MIL-F-50541A (AR)
AMENDMENT 5
27 June 1994
SUPERSEDING
AMENDMENT 4
07 December 1992

MILITARY SPECIFICATION

FUZE FOR FLECHETTE WARHEAD, WDUA/A (LESS EXPULSION CHARGE)

This amendment forms a part of MIL-F-50541A (AR), dated 8 September 1978, and is approved for use by the US Army Armament, Munitions, and Chemical Command, and is available for use by all Departments and Agencies of the Department of Defense.

FIGURE 1. Helicopter vibration.

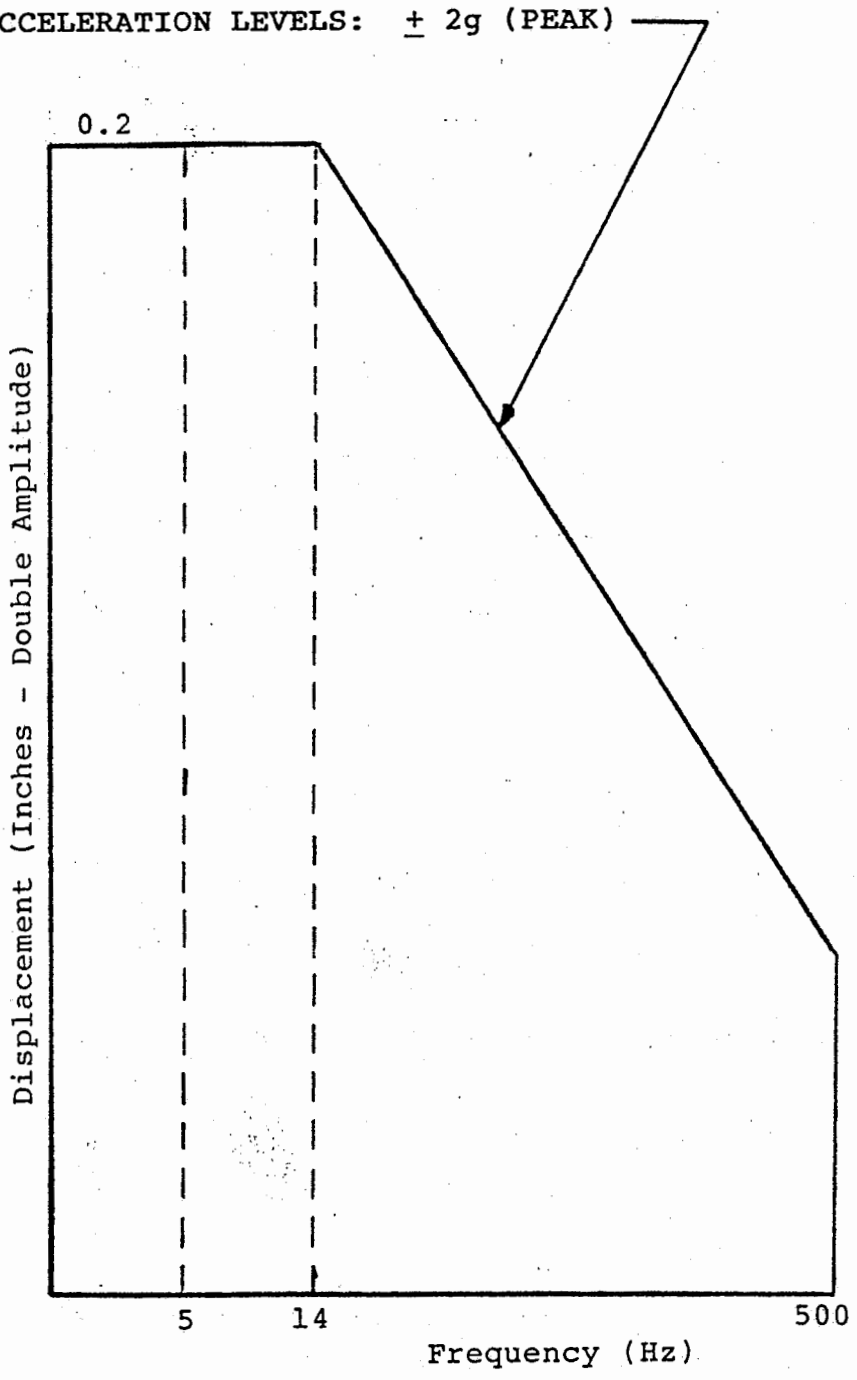
Appendix A: Delete in its entirety and substitute enclosed Figure 1.

One 15 minute sinusoidal sweep (5-500-5 Hz) shall be performed for each of three axes. No dwell time shall be spent on any one frequency. A search for resonance shall not be done.
